HISTORIC AND DESIGN REVIEW COMMISSION

HDRC CASE NO: 2026-196
ADDRESS: 427 S PRESA ST
LEGAL DESCRIPTION: NCB 904 LOT 41
ZONING: D, H, RIO-3
CITY COUNCIL DIST.: 1
DISTRICT: La Villita Historic District
APPLICANT: Timothy Proctor/Laney Development Group
OWNER: Timothy Proctor/Laney Development Group
TYPE OF WORK: Amendment to a previously approved design regarding materials, facade arrangement, and an increase in height
APPLICATION RECEIVED: July 16, 2026
60-DAY REVIEW: September 14, 2026
CASE MANAGER: Edward Hall

DURANGO APARTMENTS

HDRC Presentation

ELEVATION - SOUTH
SCALE: 1/8" = 1'-0"

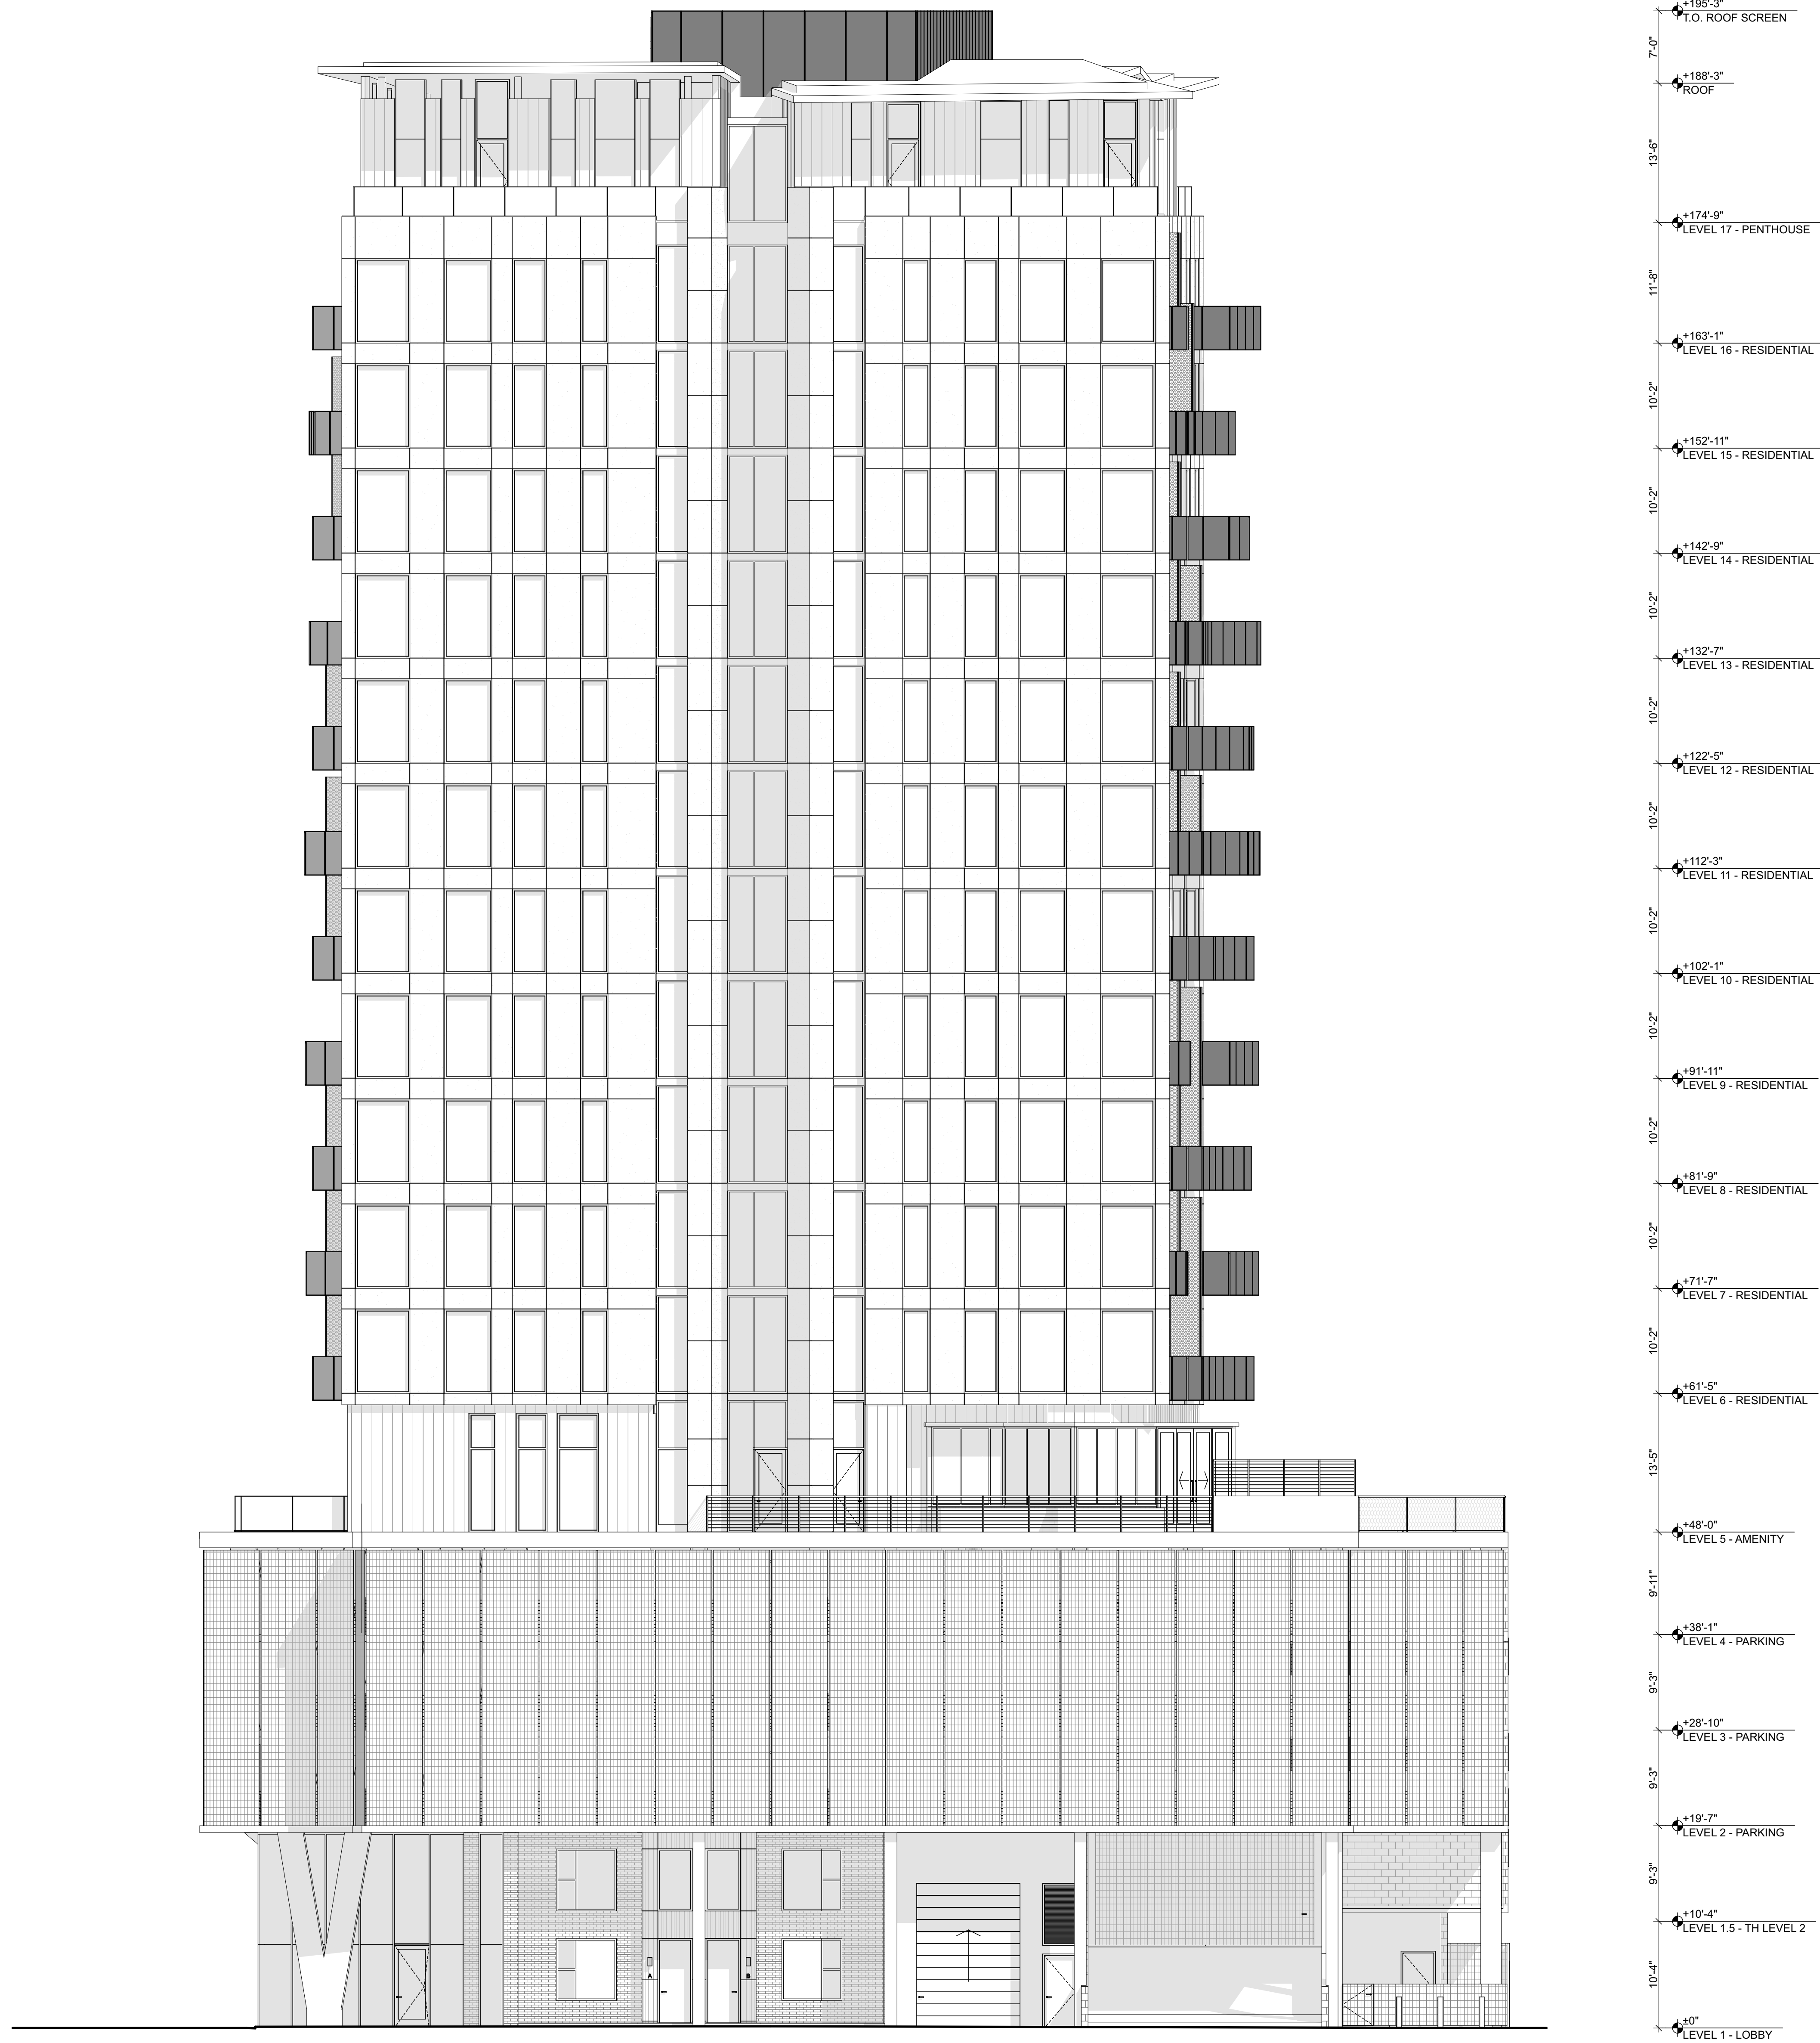
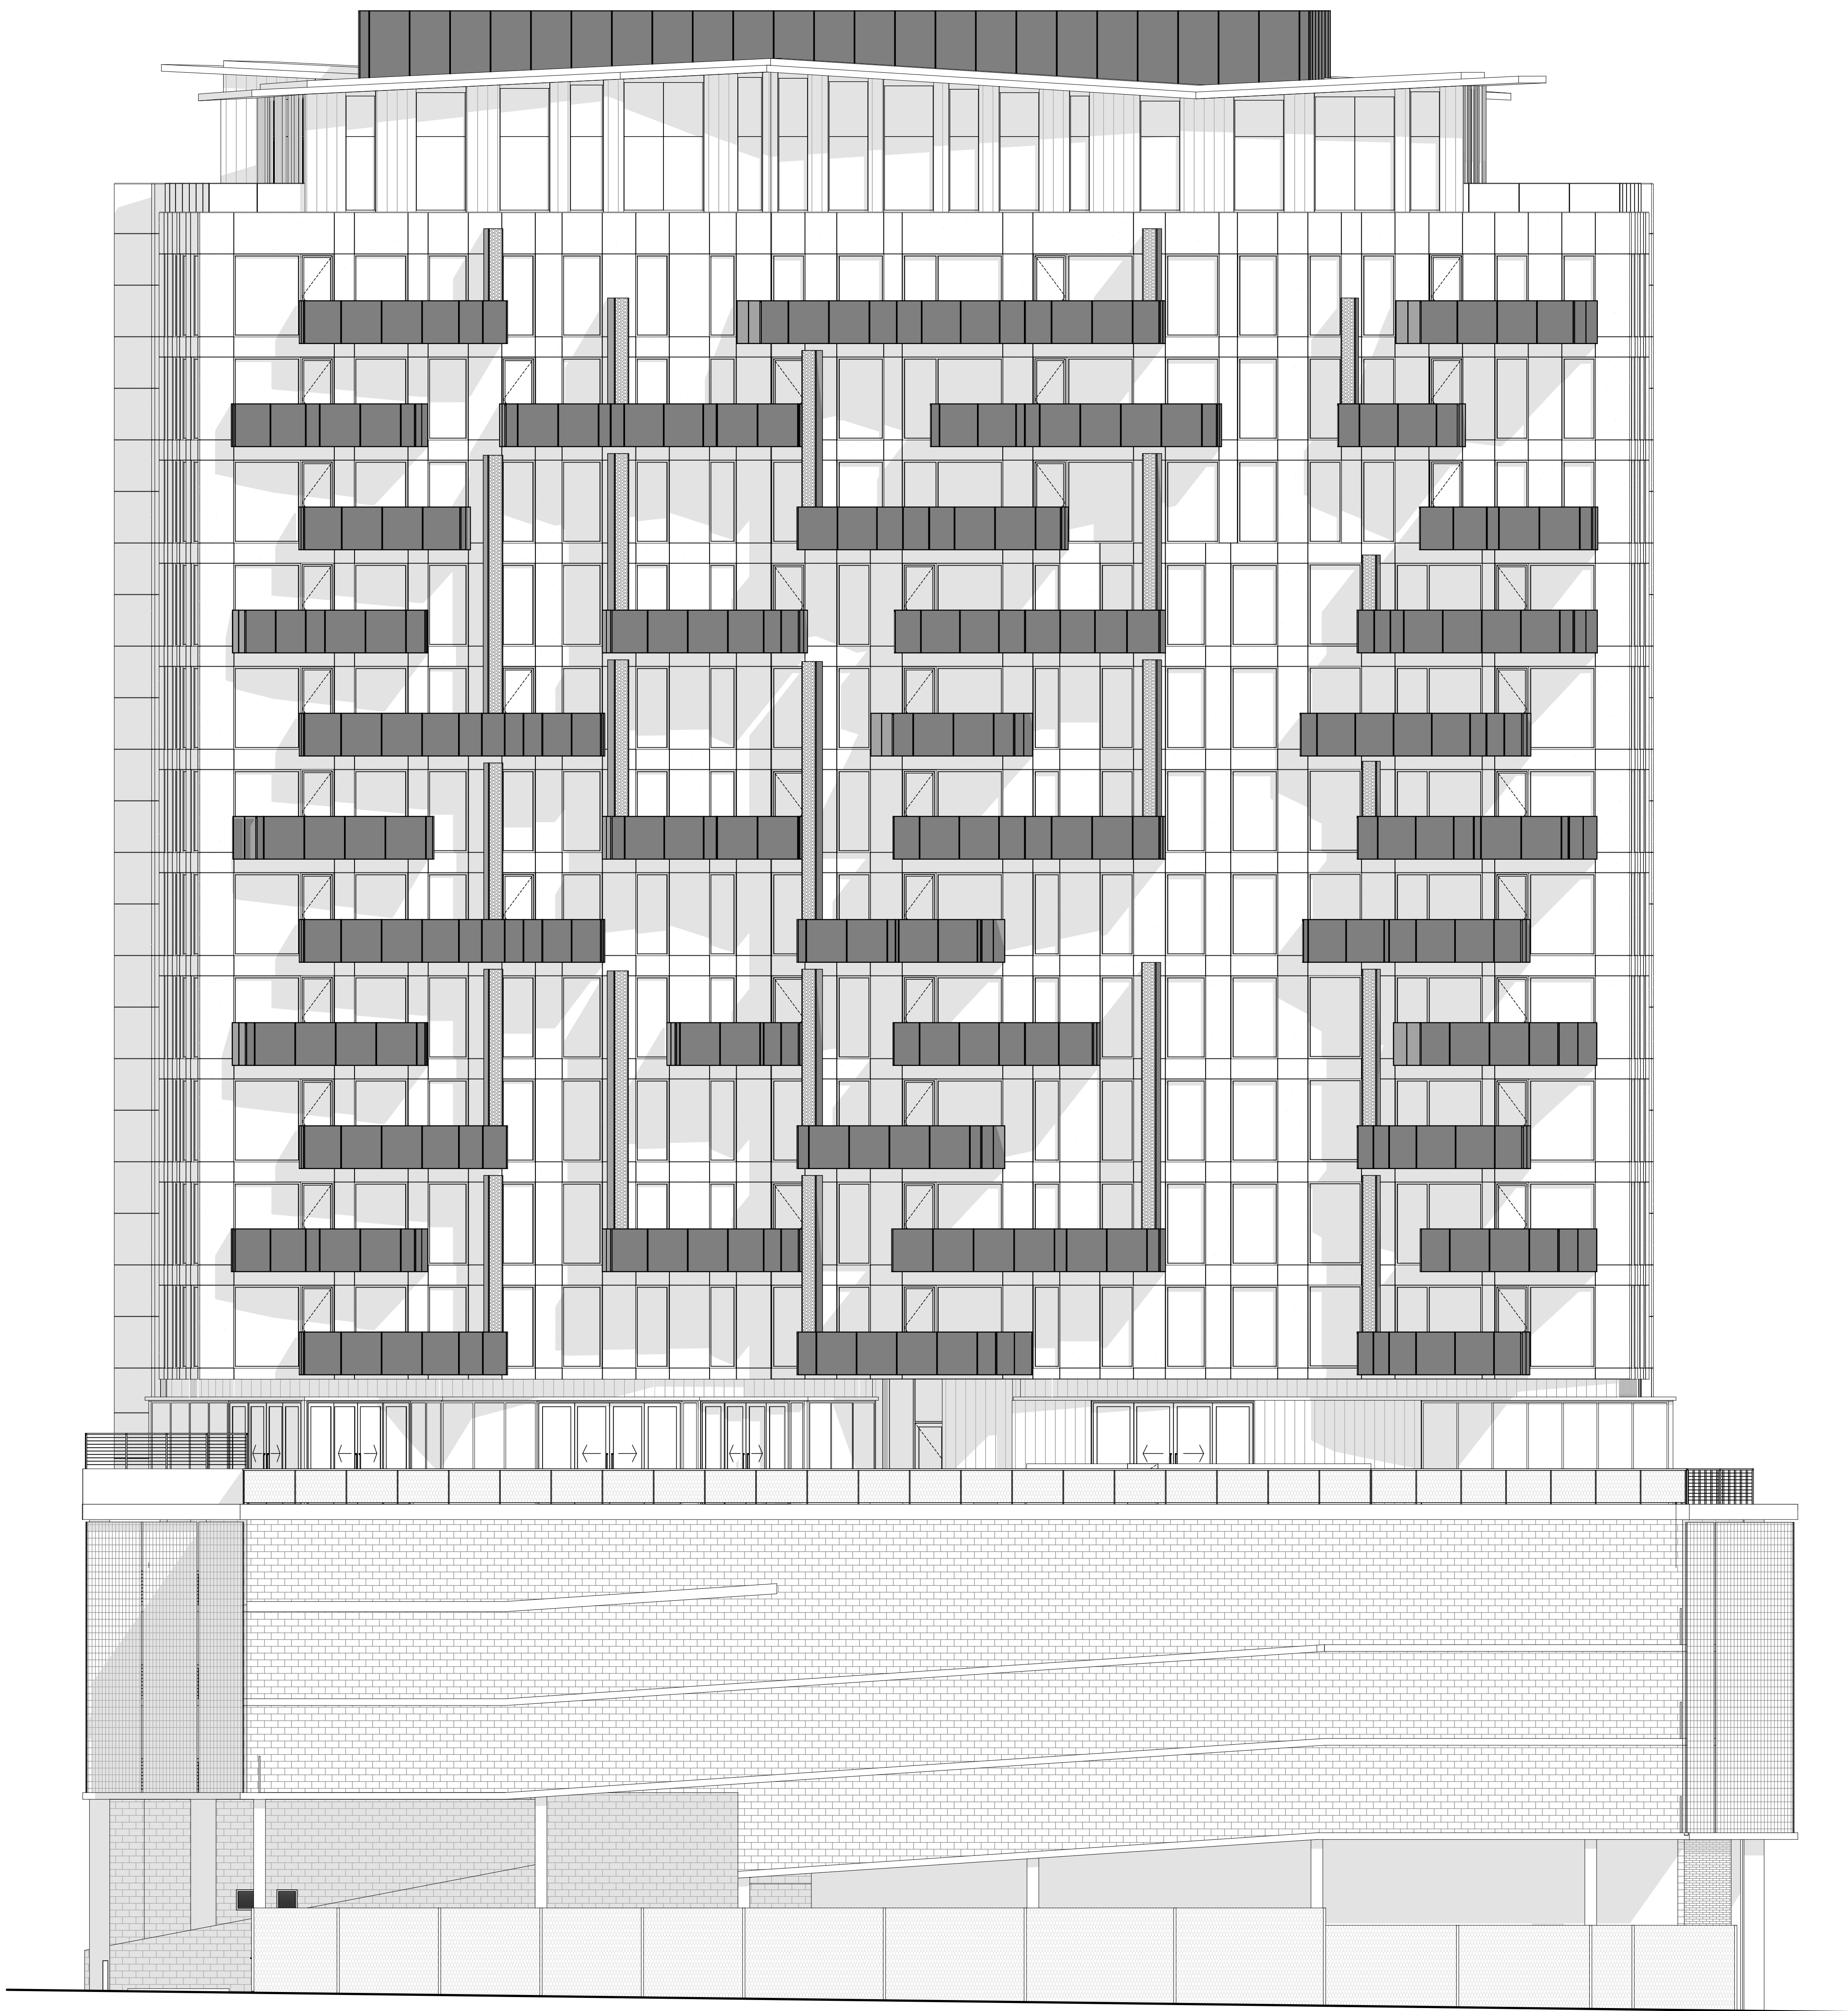
- c. HEIGHT INCREASE – The applicant has proposed to amend the previously approved design’s height by increasing the overall height from 15 stories and approximately 148’ to 17 stories and approximately 195’. The UDC Section 35-674(c)(3) states that building facades shall appear similar in height to those of other buildings found traditionally in the area. This section also states that if fifty (50) percent of the building facades within a block face are predominantly lower than the maximum height allowed, the new building façade on the street-side shall align with the average height of those lower buildings within the block face, or with a particular building that falls within the fifty (50) percent range. The majority of neighboring structures are well below the allowable building height. The applicant has proposed for pedestrian scaled façade elements at two levels of the five-level podium. Staff finds this to be compatible with the smaller scaled buildings in the immediate vicinity.

- d. HEIGHT INCREASE – HEIGHT – The River Improvement Overlay design standards for RIO-3 note no height restrictions. Additionally, the Downtown Design Guide notes that towers should appear taller than they are wide. Staff finds that the increase in height is not a departure from the merit of the originally approved design. Additionally, staff finds that the increase in height brings the proposed tower closer to compatibility with design standards regarding width to height proportions.

- e. FAÇADE MATERIALS – The applicant has proposed to install white modular brick at the street level on the east, west and south facades. A modular masonry material was previously approved in these locations. Staff finds the new material to be appropriate and consistent with the UDC.

- f. FAÇADE ARRANGEMENT – The applicant has proposed to modify the previously approved façade arrangement by increasing the overall size of fenestration on each façade. Staff finds the proposed amended façade arrangement and fenestration size to be appropriate and consistent with the UDC.

Staff recommends approval of items #1 through #3 based on findings a through g with the following stipulations:
